# Airways New Zealand submission to the Civil Aviation Authority's 2016 Manawatu Airspace Review

Prepared by: John Wagtendonk  
Policy, Standards and Safety Improvement

7 January 2016

## 1. Additional Ohakea CTA

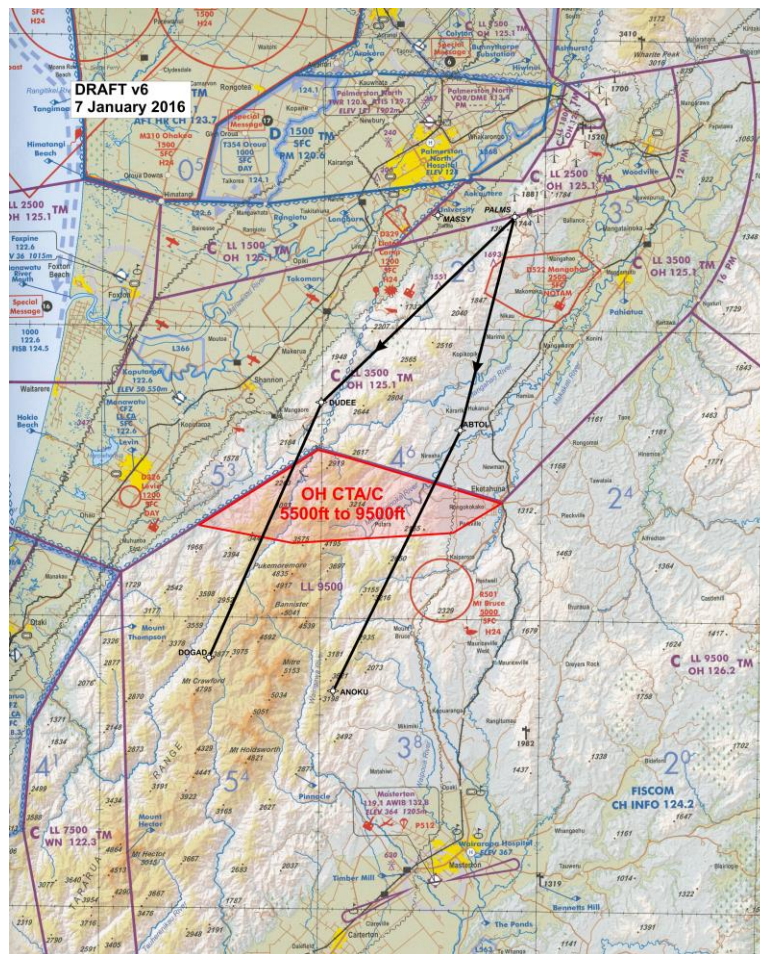
Airways request the addition to the Ohakea control area of a new CTA 5,500ft to 9,500ft to the south of Palmerston North as depicted on the diagram below.

The reason for this additional CTA is to provide airspace containment for proposed new PBN departures from Palmerston North tracking to the south.

The additional CTA would also provide for correct containment of existing IFR flights climbing southbound from Palmerston North.

The CTA would also provide for containment of a proposed new holding pattern to the south east of Ohakea associated with an approach to Ohakea runway 33.

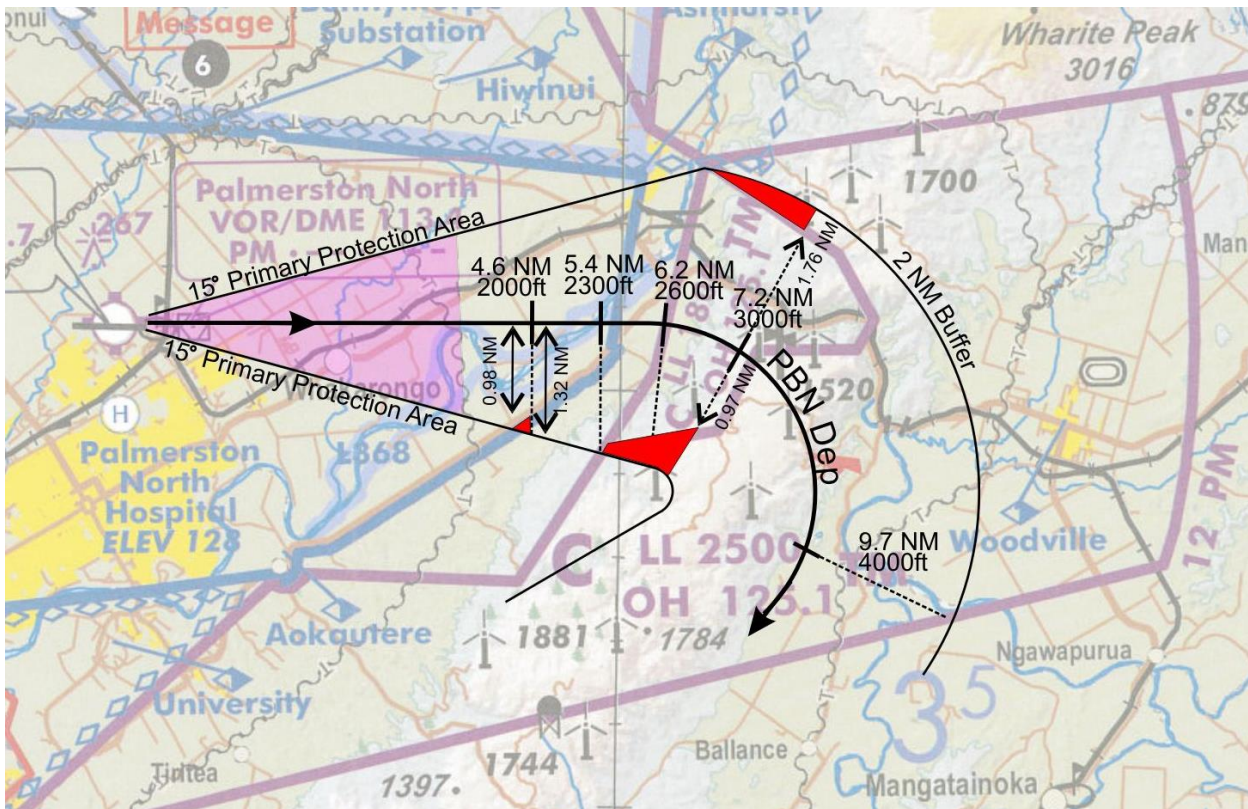
The diagram below depicts the proposed PBN departure that turns right off PM RWY 07. The containment criteria applied is the 15 degree primary protection area until it reaches 2 NM wide; thereafter it is a 2 NM buffer.

The diagram depicts some profile levels on the departure – i.e. at 4.6 NM, the profile level is 2,000ft AMSL, at 5.4 NM 2300ft, at 6.2 NM 2600ft at 7.2 NM 3000ft and at 9.7 NM 4000ft.

Bearing in mind that the departure profile needs to be at least 500ft above the lower limit of the airspace, the diagram above depicts 3 areas (in red) where the existing airspace does not fully contain the departure. These are;

1. The PM CTR needs to contain the departure until the profile passes 2000ft at 4.6 NM. This doesn't happen. Where the profile passes 2000ft, the CTR should be 1.32 NM wide but the existing CTR is only 0.98 NM wide – 0.34 NM less than it needs to be. A small triangular shaped increase in the CTR would be needed for full containment.
2. On the inside of the turn, between 5.4 NM and 7.2 NM the containment buffer reduces to 0.97 NM.
3. On the outside of the turn, between 6.2 NM and 7.2 NM the containment buffer reduces to 1.76 NM.

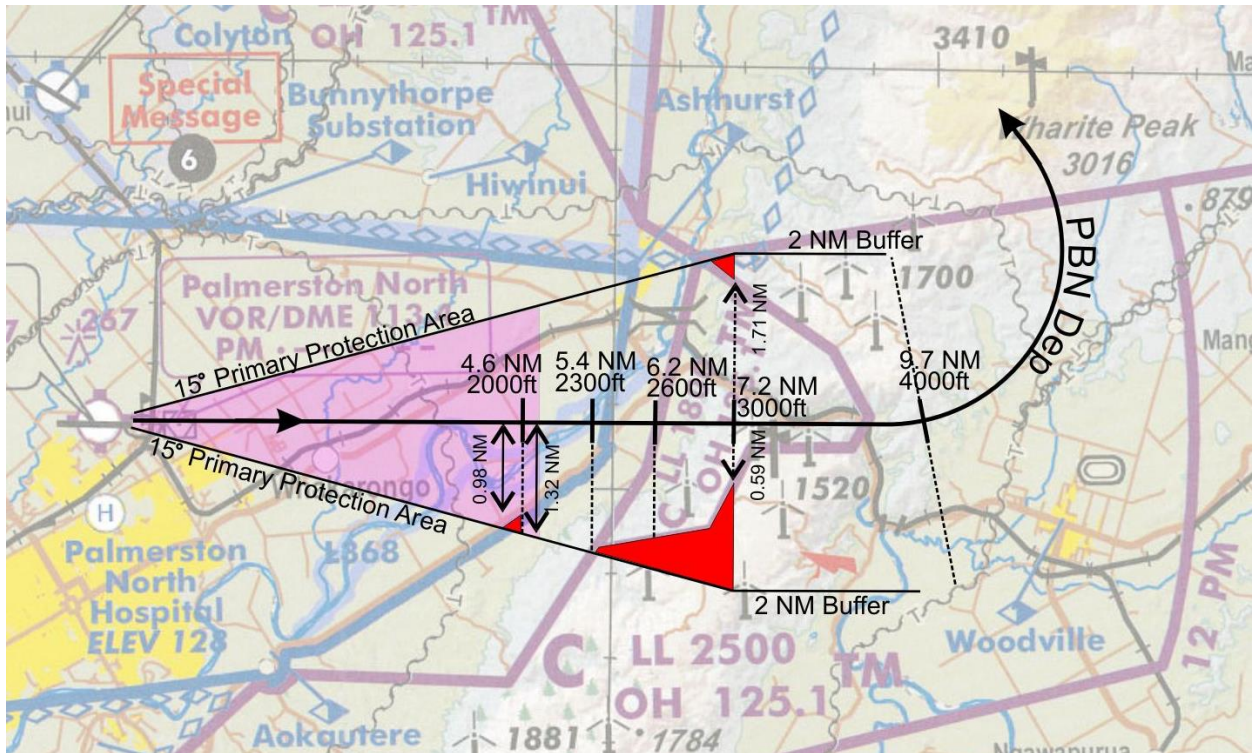
The proposed PBN departure to the north also has containment issues with the existing airspace as indicated in the diagram below by the red areas.

The lack of containment by the CTR is the same as for the right turning departure.

Between 5.4 NM and 7.2 NM, containment to the south reduces to 0.59 NM. To the north it reduces to 1.71 NM.

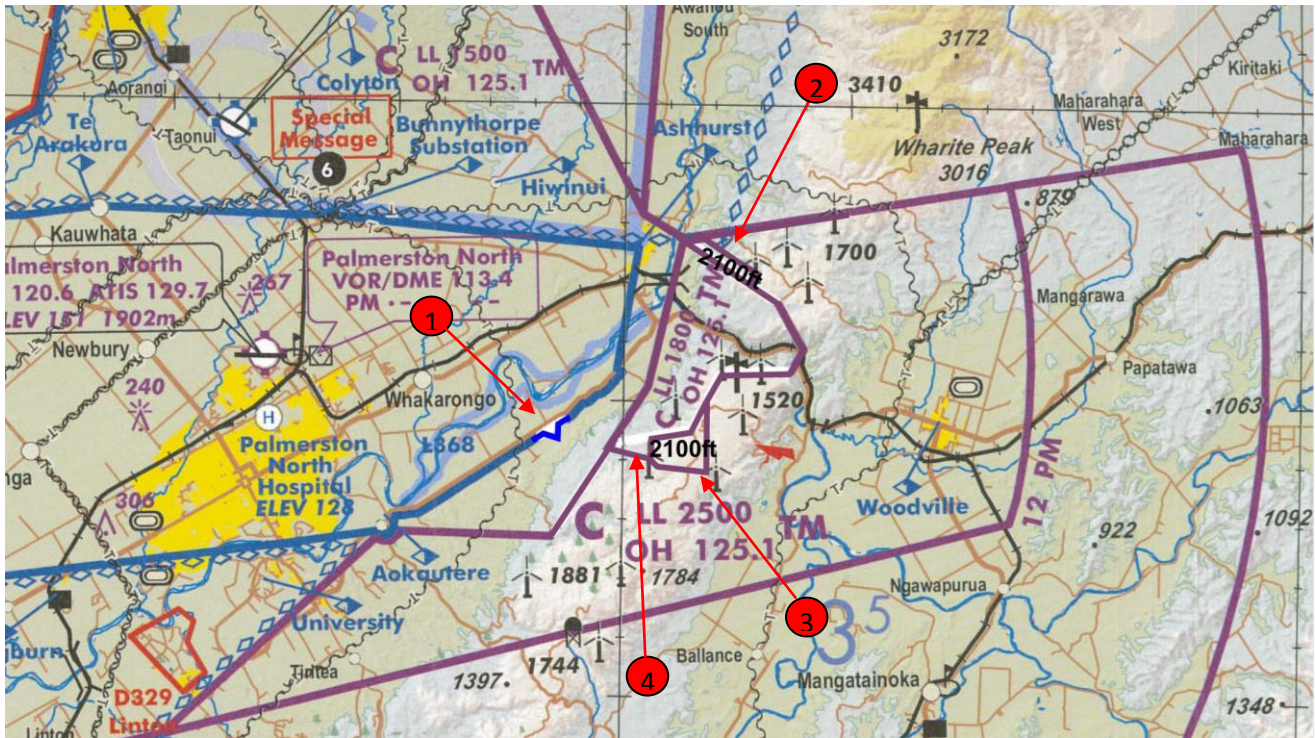
To provide full containment of the proposed new PBN departures off PM RWY 07 the PM CTR and OH CTA would need to be amended as depicted in the diagram below. This adds;

1. a small triangular increase to the PM CTR along the south-eastern boundary; and
2. a new CTA portion LL 2100 ft east of Ashhurst; and
3. a new CTA portion LL 2100 ft along the ranges south of the Manawatu Gorge; and
4. a small extension of the existing CTA LL 1800 ft to the south

Incorporating the 2100 ft CTA portions into the existing 1800 ft CTA is not possible as the CTA would be less than the required 700ft above the surface of the earth.

Whilst the additional areas of controlled airspace are what are required for full containment, Airways believe there would be practical and safety issues with such small areas of controlled airspace such as depiction on charts and pilots being able to determine where the boundaries are. Also, VFR flights avoiding the new airspace would need to be closer to the terrain.

1. change the PM CTR and OH CTA to include the additional airspaces in order to provide full containment of the PBN departures; or
2. leave the PM CTR and OH CTA boundaries where they currently are and accept the reduced airspace containment of the PBN departures; or
3. leave the PM CTR and OH CTA boundaries where they are and advise Airways that PBN departures need to be fully contained. This would preclude the implementation of the proposed PBN departures. CAA should also consider the lack of containment of the existing departures and the only alternative then is to increase the climb gradient to more than 6.5%.
